Safety Recall

N242441392 Right Side Seatbelt Retractor May Lock

Revision: 01

Revision Description: This bulletin is being revised to update the inspection steps in the service procedure. Please discard all previous copies of bulletin N242441392.

6682024

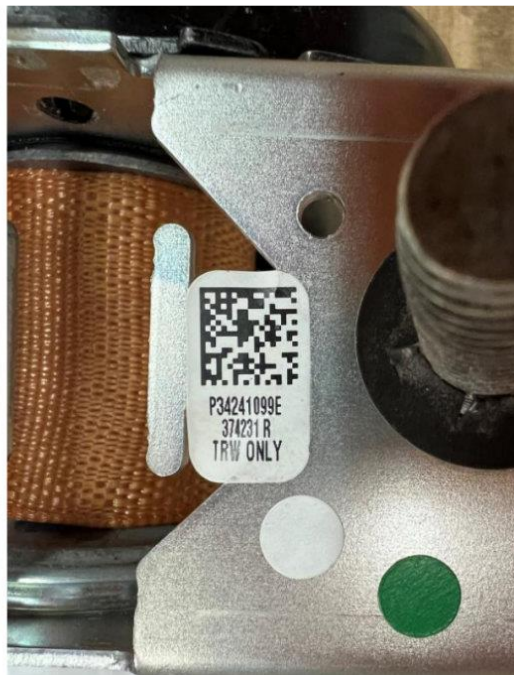
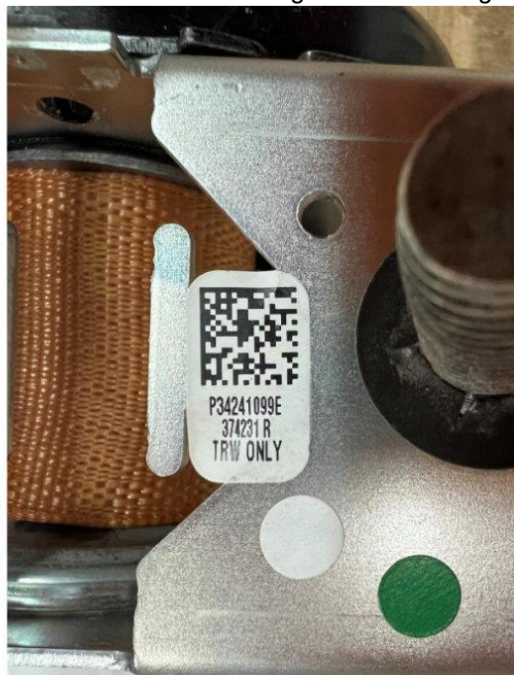
1. Inspect the NEW Seatbelt Retractor label located on the bottom of the Seatbelt Retractor.
 - If the 4th and 5th digits are "23" AND the 1st and 2nd digits range between "35"- "52", , The part is BAD and MUST be scrapped. DO NOT INSTALL ON VEHICLE. Reference the Scrap Instructions below. Re-order a replacement Seatbelt Retractor and repeat inspection.
 - If the 4th and 5th digits are "23" AND the 1st and 2nd digits DO NOT range between "35"- "52" proceed to Step 2.

6682024

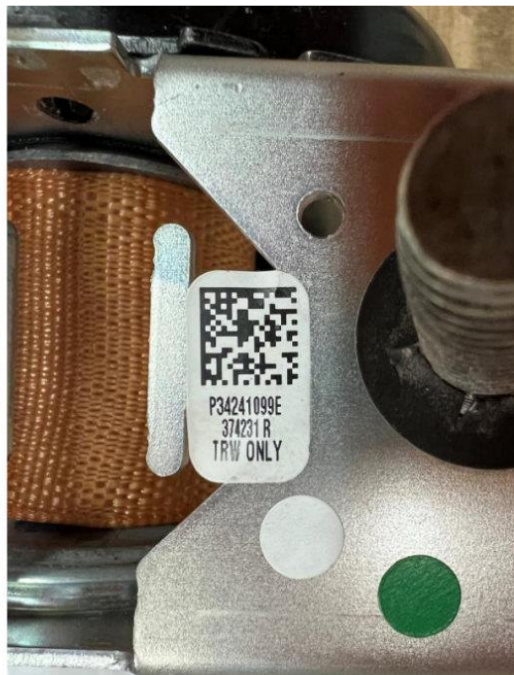
2. Continue to inspect the NEW Seatbelt Retractor label located on the bottom of them retractor.
 - If the 4th and 5th digits are "24" AND the 1st and 2nd digits are "01", ", The part is BAD and MUST be scrapped. DO NOT INSTALL ON VEHICLE. Reference the Scrap Instructions below. Re-order a replacement Seatbelt Retractor and repeat inspection.
 - If the 4th and 5th digits are "24" AND the 1st and 2nd digits are NOT "01" proceed to Step 3.
3. Replace the RH Front Seat Belt Retractor. Refer to *Front Seat Belt Retractor Replacement* in SI. If convertible, refer to *Front Seat Belt Retractor Replacement - Right Side (Convertible)* in SI.
4. Scrap all replacement Seat Belt Retractors that failed inspection steps 1 and/or 2 AND the used Seatbelt Retractor. Refer to the Scrap instructions below.
